Recall Campaign Bulletin

Campaign No. 2003040005  
 May 2003

SUBJECT: MODEL 163,154/157/172/174/175  
 REPLACEMENT OF CLAMP FOR LOWER POWER STEERING HOSE DUE TO  
 POSSIBLE FLUID LOSS AT RADIATOR

Figure 1

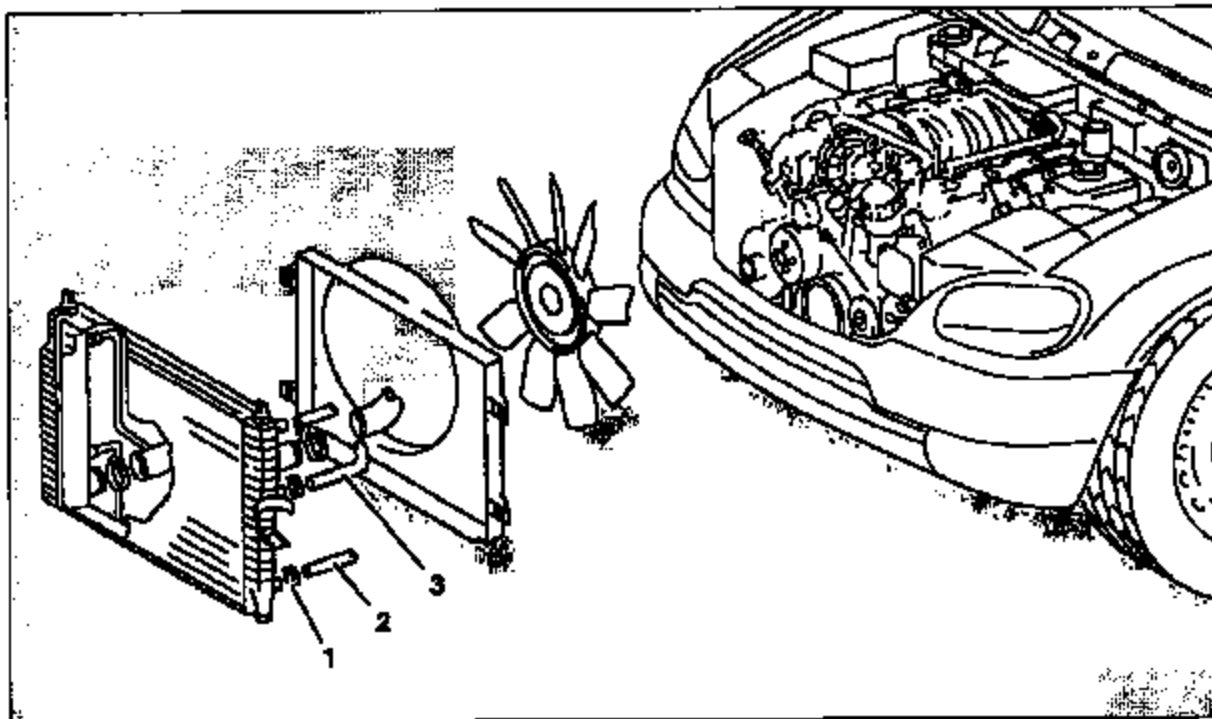
DCAG has determined that the lower power steering hose clamp (1, Figure 1) located on the lower power steering hose (2, Figure 1) at the lower left hand corner of the radiator must be replaced. The hose clamp may not provide sufficient clamping force for this connection and may cause fluid loss. Please review the Effective Serial Number Chart located on page 2. Attached is a sample copy of a letter which owners of the affected vehicles will receive.

1. Prior to performing this Recall Campaign, please check VMI to insure the vehicle is involved and to determine if the vehicle has been previously repaired.
2. Shut-off engine and remove ignition key from ignition lock.
3. Open engine hood.
4. Visually locate both upper (3, Figure 1) and lower (2, Figure 1) power steering hose and then using MBUSA Special Tool: 000 598 40 37 00, clamp off (near radiator) both upper and lower power steering hoses to prevent any fluid leaks.
5. Carefully loosen only, the existing hose clamp (1, Figure 1) and then slide hose clamp away from the radiator. Do not remove existing hose clamp at this point.

In order to prevent power steering fluid leak, do not disturb or remove lower power steering hose (2, Figure 1) in any way.

6. Carefully inspect the condition of the lower power steering hose (2, Figure 1) at the radiator.

7. Open replacement hose clamp just enough for clamp to fit over the outer circumference of the lower power steering hose (2, Figure 1).

8. Slide the installed new hose clamp toward the radiator and locate in the proper position on the lower steering hose (1, Figure 1) as shown and tighten hose clamp screw.
- Ⓢ Observe tightening torque of: Nm 2.0 +0.05/-0.1
9. Remove previously loosened old hose clamp (see step 5) from hose at this point.
10. Loosen and remove previously installed MBUSA Special Tool: 000 588 40 37 00 from both upper and lower power steering hoses.
11. Start-up engine and check for any fluid leaks from the power steering hoses at the radiator.

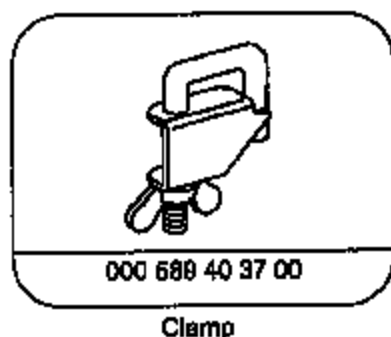
When installing new hose clamp, do not open hose clamp any more than necessary in order for hose clamp to fit over the lower power steering hose itself, otherwise the hose clamp may be damaged.

**NOTE:** The new replacement hose clamp must have the number "15" stamped into the outer circumference of the hose clamp surface.
